**To:** Kristopher Byrd, Well Construction and Compliance Section Manager  
**From:** Travis Kelly, Well Construction Program Coordinator  
**Subject:** Review of Water Right Application G-18908  
**Date:** May 26, 2020

Application # G- 18908

**SUBJECT: Scenic Waterway Interference Evaluation**

TO: Water Rights Section Date: 5/26/2020  
 FROM: Groundwater Section Travis Brown  
Reviewer's Name  
 SUBJECT: Application G- 18908 Supersedes review of \_\_\_\_\_  
Date of Review(s)

D1. Well #: 1 Logid: MARI 17438

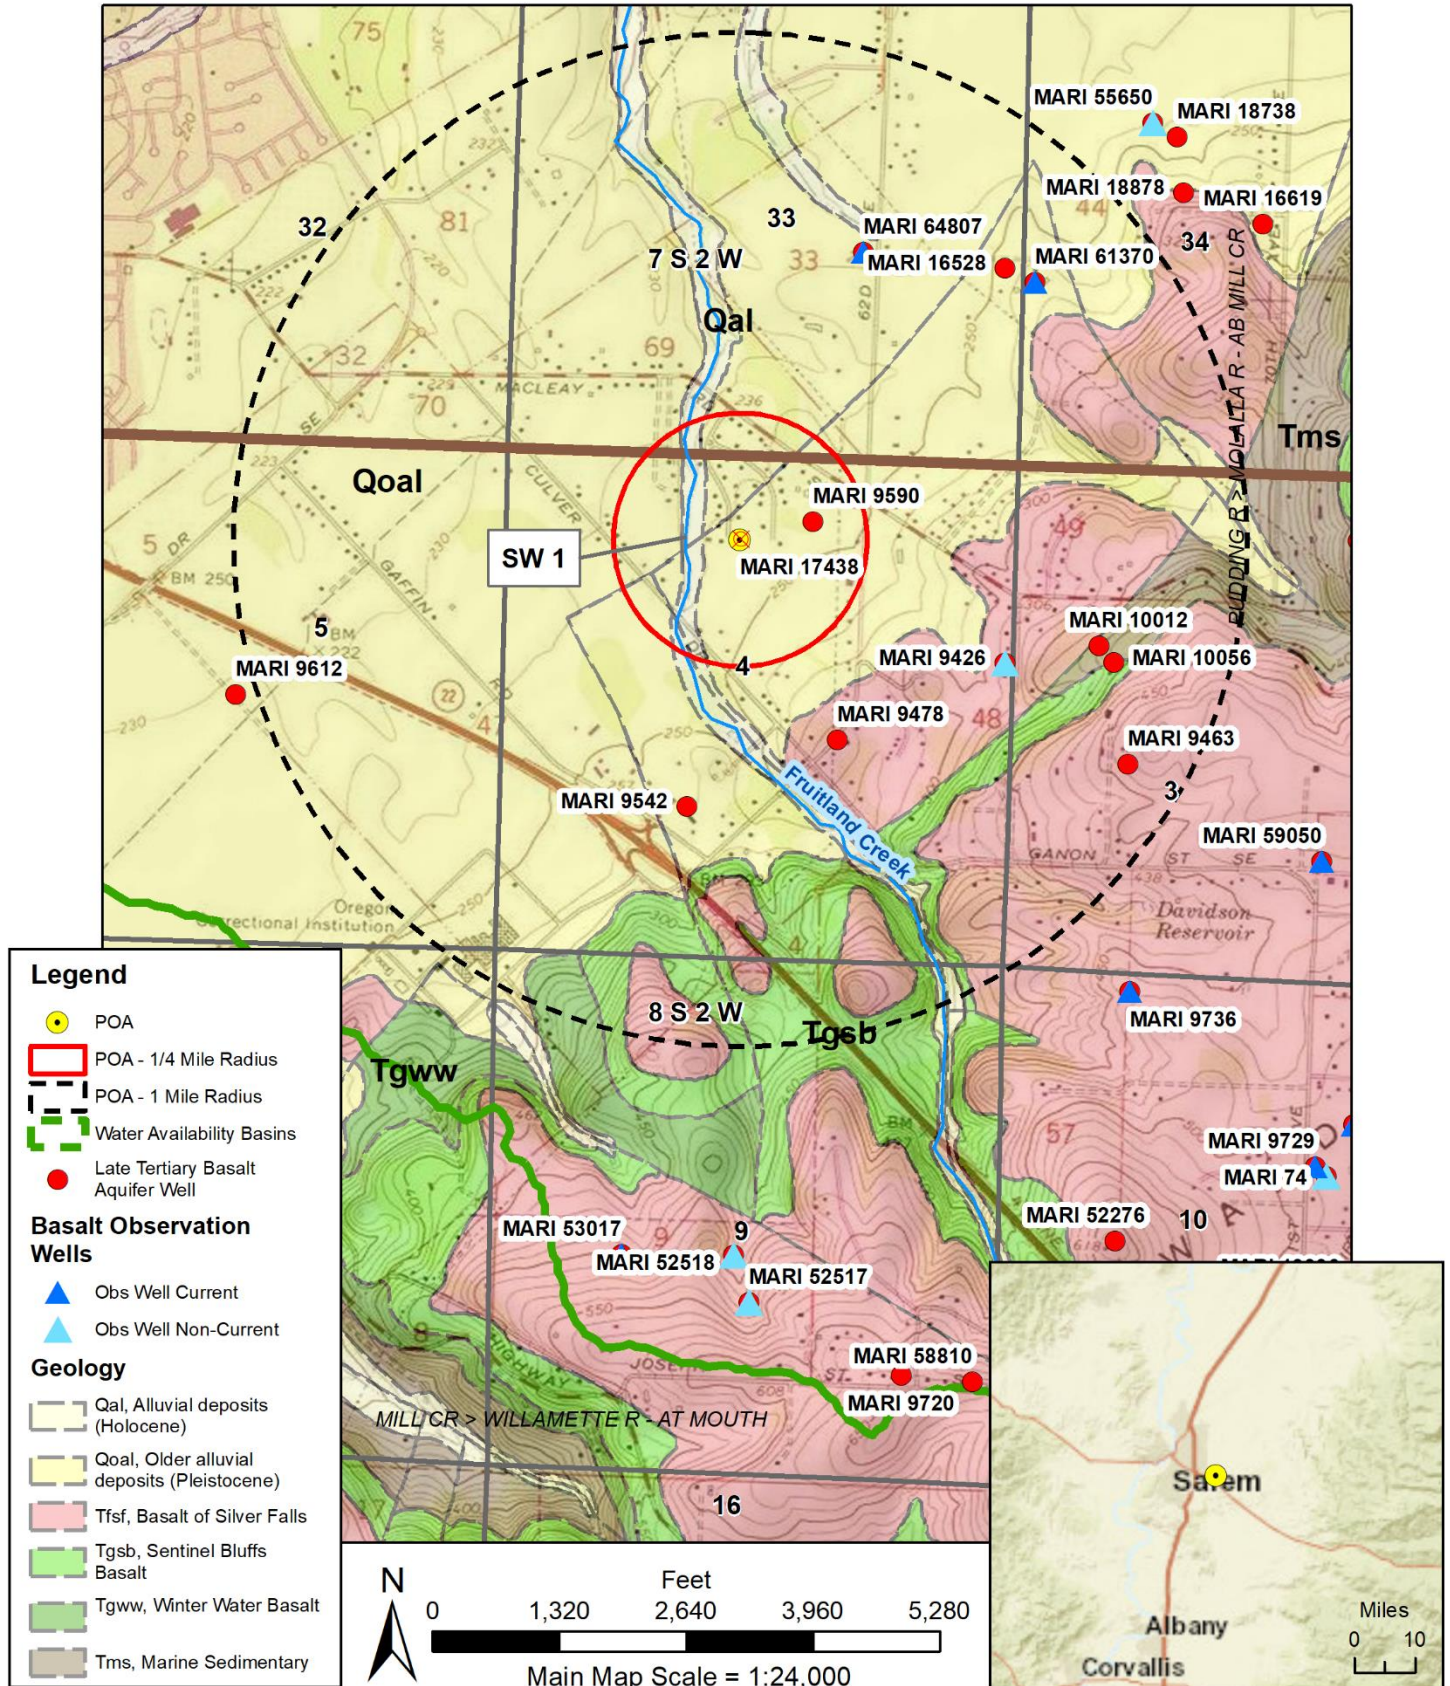
D2. **THE WELL does not appear to meet current well construction standards based upon:**

D3. **THE WELL construction deficiency or other comment is described as follows:** The well appears to be open to both the alluvial aquifer system ("Sandy Clay w Gravel", depth 73-94 ft bls, static water level [SWL] 21 ft bls) and the Columbia River Basalt (CRB) aquifer system ("Basalt Fractured", depth 183-193 ft bls, SWL 27 ft bls) (see attached Well Construction Diagram), possibly allowing for commingling. The seal ("Neat Cement") extends only to 35 ft bls; however, competent basalt ("Basalt Hard Med") is not reported until 106 ft bls, with at least one alluvial water-bearing zone in the intervening depths. The application indicates "Basalt" as the target aquifer. Based on the well log for MARI 17438 and the Well Construction Rules (OAR 690-200 and 690-210), the seal for MARI 17438 should extend at least 5 ft into hard, dense basalt – to at least 111 ft bls.

D4.  **Route to the Well Construction and Compliance Section for a review of existing well construction.**

### Hydrographs

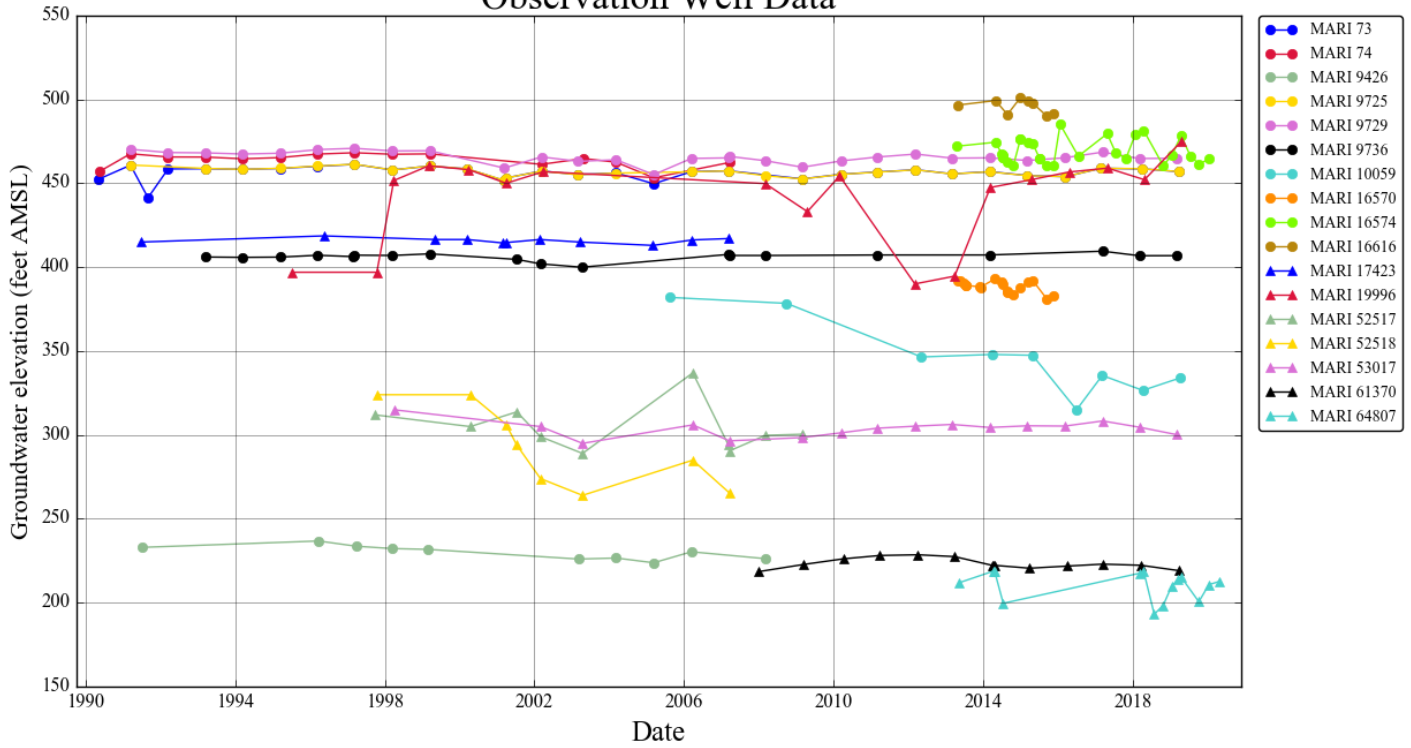
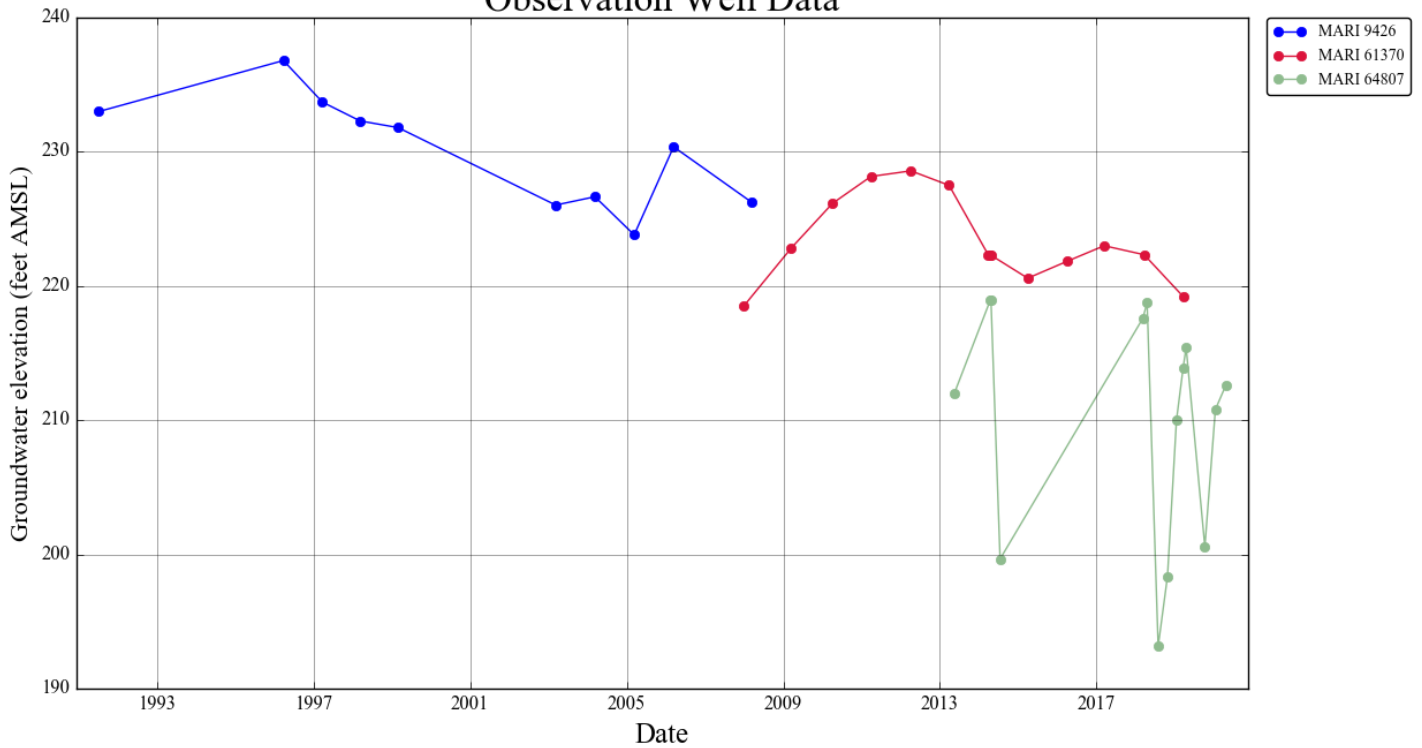
Reported water levels in this area indicate general stability within the basalt aquifer system, although the wells nearest to the proposed POA do indicate modest declines (see attached Hydrographs). Due to the unknown degree of compartmentalization in this area as well as the potential for the basalt aquifer system to contain multiple, hydraulically-distinct aquifers stacked on top of each other, the extent to which broader aquifer system trends reflect the status of the aquifer tapped by the proposed

POA is unknown. **As such, the conditions specified above are strongly recommended. Additionally, the following Special Conditions are recommended:**

- A. Each basalt well shall be open to a single aquifer of the Columbia River Basalt Group and shall meet the applicable well construction standards (OAR 690-200 and OAR 690-210).  
In addition, the open interval in each well shall be no greater than 100 feet. An open interval of greater than 100 feet may be allowed if substantial evidence of a single aquifer completion can be demonstrated to the satisfaction of the Department Hydrogeologists, using information from a video log, downhole flowmeter, water chemistry and temperature, or other downhole geophysical methods. These methods shall characterize the nature of the basalt rock and assess whether water is moving in the borehole. Any discernable movement of water within the well bore when the well is not being pumped shall be assumed as evidence of the presence of multiple aquifers in the open interval.  
If during well construction, it becomes apparent that the well can be constructed to eliminate the commingling of aquifers and/or interference with hydraulically connected streams in a manner other than specified in this permit, the permittee can contact the Department Hydrogeologist for this permit or the Groundwater Section Manager to request approval of such construction. The request shall be in writing and shall include a rough well log and a proposed construction design for approval by the Department. The request can be approved only if it is received and reviewed prior to placement of any permanent casing and sealing material. If the request is made after casing and seal are placed, the requested modification will not be approved. If approved, the new well depth and construction specifications will be incorporated into any certificate issued for this permit.
